SUBJECT: **SPEX 2009-0004, SPEX 2009-0015 & CMPT 2009-0003; Scott Jenkins Memorial Park**
LCTM: 37/58A & 58B (PIN 346-35-3765 & 346-36-7436)

We have addressed the second referral comments for The Scott Jenkins Memorial Park and offer the following in response. The letter responds to the returned referrals in the chronological order they were written. In an effort to abbreviate the letter and focus on the addressing outstanding issues this letter only addresses items that need clarification and response from the applicant.

We have addressed the first referral comments for The Scott Jenkins Memorial Park and offer the following in response. The letter responds to the returned referrals in chronological order they were written.

County of Loudoun
Department of Planning
MEMORANDUM

FIGURE C-1-8 GUIDELINES FOR RIGHT TURN TREATMENT (2-LANE HIGHWAY)

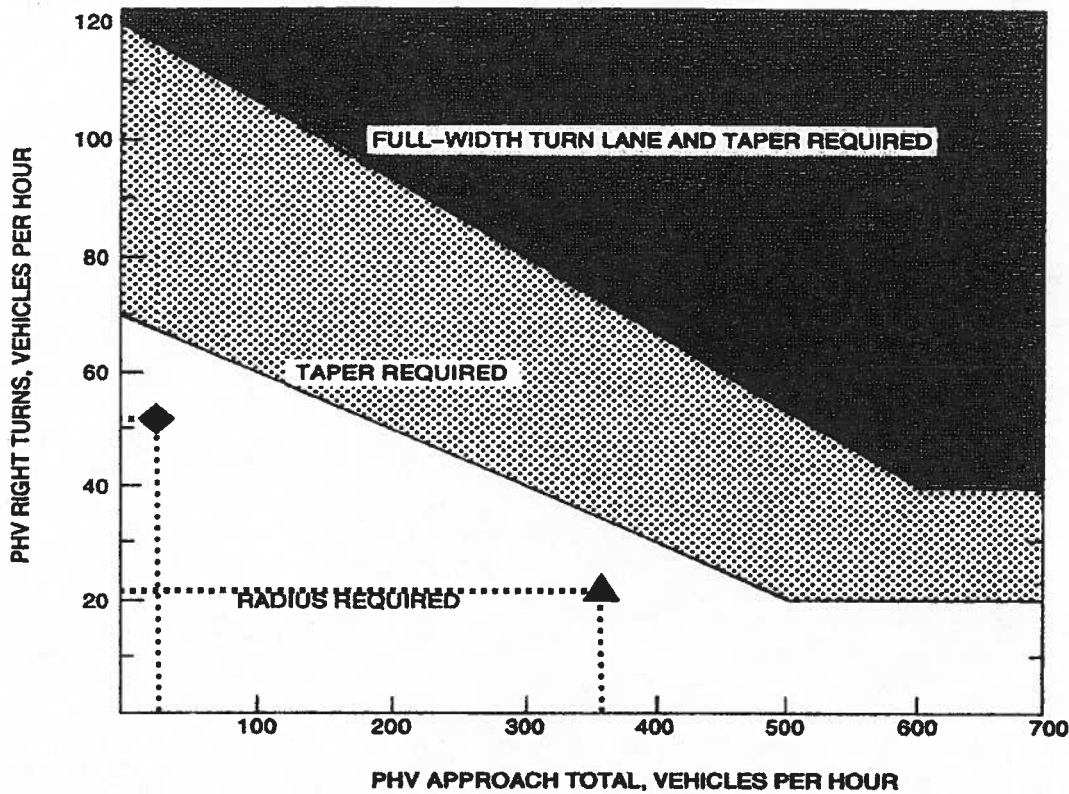
2. *OTS staff requests further explanation of the "alternative length" measurement used in the traffic study (Attachment 16). In addition, OTS would like to know why the westbound left-turn lane length provided at the main site entrance (510 feet) is shorter than the maximum length (550 feet) noted in the study (Attachment 16).*

Response: The table was derived by PHR+A from VDOT Location and Design calculations for another public road project in the County. The alternative AASHTO column was shown to reflect the VDOT L&D, Traffic Engineering, and Land Development direction that the AASHTO turn lane standards could be satisfied based on the length of turn lane and storage. No written standards have been adopted by VDOT other than revisions to the VDOT Road Design Manual. However, based on current land use application review regarding design waivers, since Business Route 7 is not a National Highway System route, the application of the VDOT Road Design Manual minimum turn lane standards should apply. For a 55 MPH speed limit, the turn lane storage is based on capacity analyses for urban conditions with a minimum storage length of 200 feet. A 200 foot taper is required for roads with over 45 MPH design speed. For the subject site use, PHR+A revised Table 10, as attached, to show the storage requirements in relation to VDOT Road Design standards and concluded that the turn lane are adequate. The comparisons also show the minimum turn lane requirements for AASHTO guidelines for 50 and 55 design speeds, for comparison purposes. The left turn lane into the site at 510 feet (410 ft turn plus 100 ft taper) allows for storage and deceleration per AASHTO minimum requirements at 50 MPH design, and exceeds the minimum VDOT standards of 400 feet. VDOT review did not highlight any turn lane issues.
